Architect's Field Report

15094 Community Bank Headquarters / Report Number 029

12 November 2021

Figure 9 – This opening at column line E is crooked at the top corner

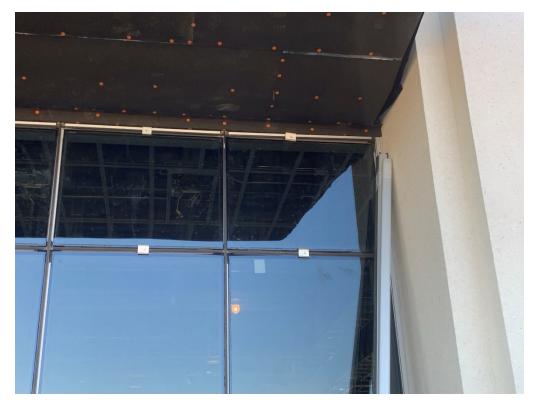
Figure 10 – This opening at column line E is crooked at the top corner

Figure 25 – Mis aligned repair (Is this repair complete or ongoing?)

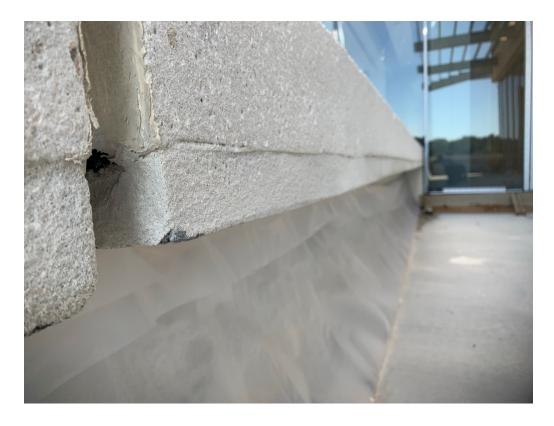
Figure 24 – Are we still awaiting remediation on the sill stones? (these don't line up at the top)

Figure 26 – Mis aligned repair (Is this repair complete or ongoing?)
